CITY OF SUN VALLEY
PLANNING AND ZONING COMMISSION
AGENDA REPORT

Meeting Date: August 15, 2013

Agenda Item: **Monson Residence Addition**
Design Review Application No. DR 2013-27

SLOPE ANALYSIS
MONSON ADDITION
SUN VALLEY, ID

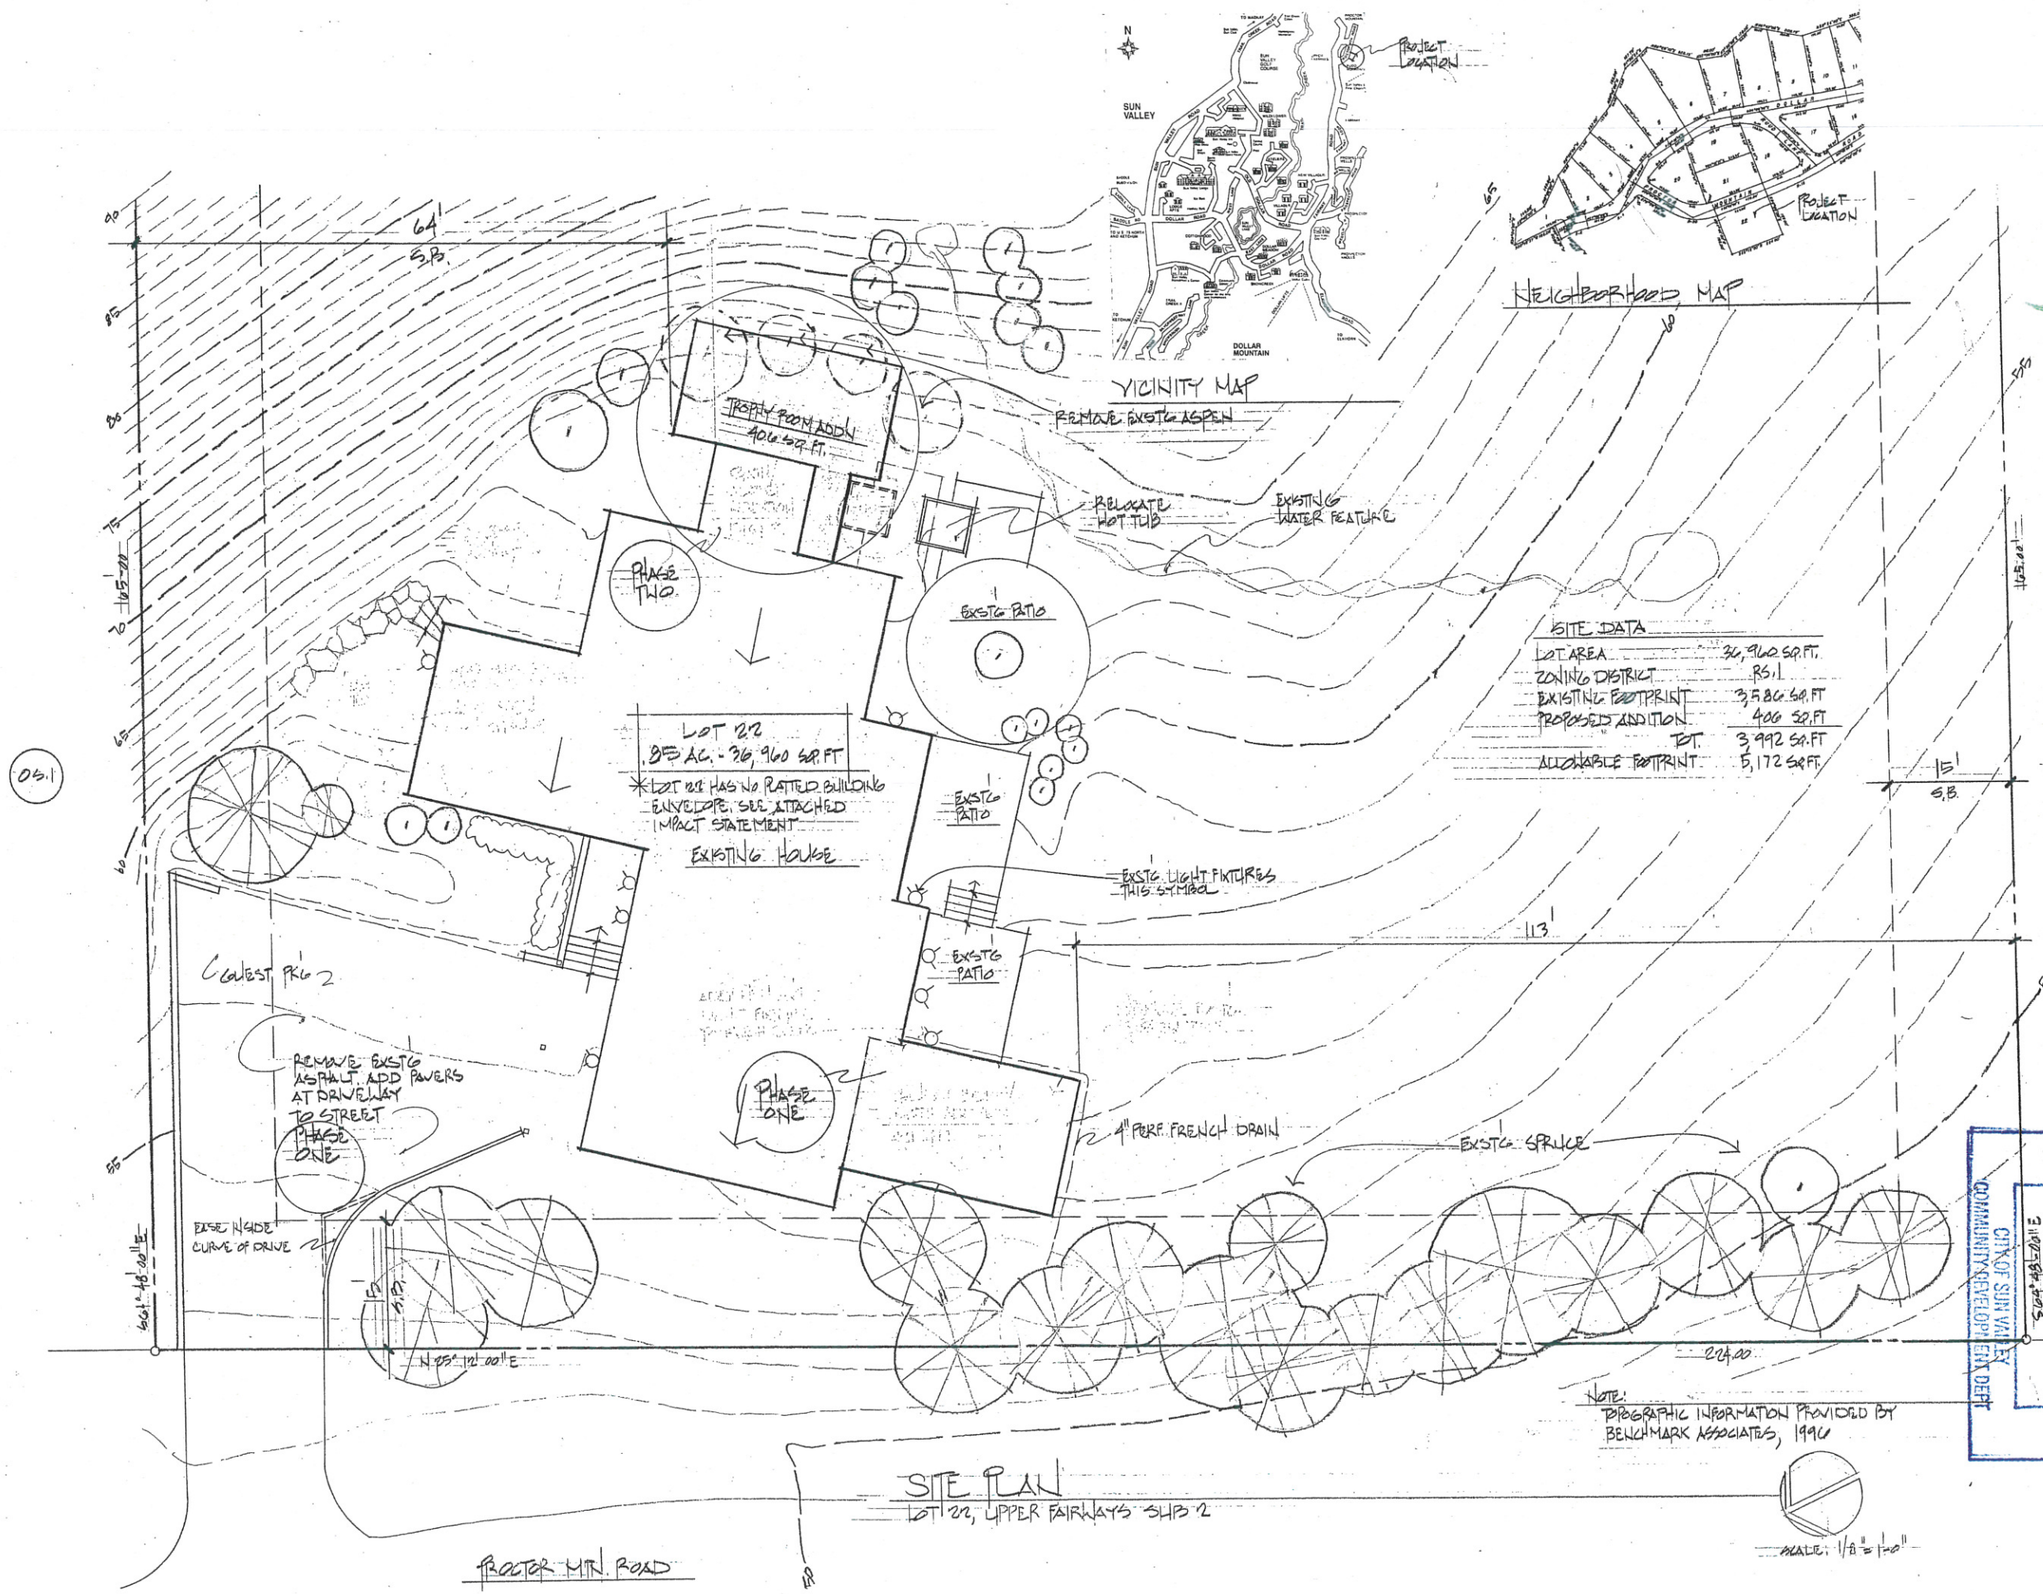
Hillside Preservation- Sheet 2 of the attached Project Drawings (**Exhibit "PZ-D"**) details the sloped area directly behind the existing single family dwelling. A portion of the addition is located beyond the line denoting the 25% slope area. The City's hillside preservation regulations generally prohibits development in areas of steep slope above 25%. The applicant provided the Slope Analysis as part of the application materials to demonstrate that the sloped area at the rear of the dwelling is disturbed and graded for construction of the initial house. Areas further up slope were retained in a natural state. The addition does not intrude on any natural sloped area but is confined to a small area of previously graded slope. The purpose of the City's hillside regulations is preservation of natural slopes. The addition is located at the rear area of an existing single family dwelling and is largely not visible from adjacent properties. The slope intrusion can be found by the Commission to be acceptable due to the man-made nature of the affected slope area and that all remaining sloped areas will be preserved as part of the project design and the required construction management plan.

dogs, garbage, safety, etc., as well as any comments and issues identified by the Planning and Zoning Commission during the public hearing. The applicant is required to limit the area of disturbance along the rear area of the dwelling and addition to preserve the hillside and open area habitat from construction damage. Temporary green construction fencing shall be placed and maintained to prohibit intrusion and disturbance in hillside and open area habitat areas.

1. Landscape plan will need to show proper surface drainage around structure.
2. No other apparent discrepancies.
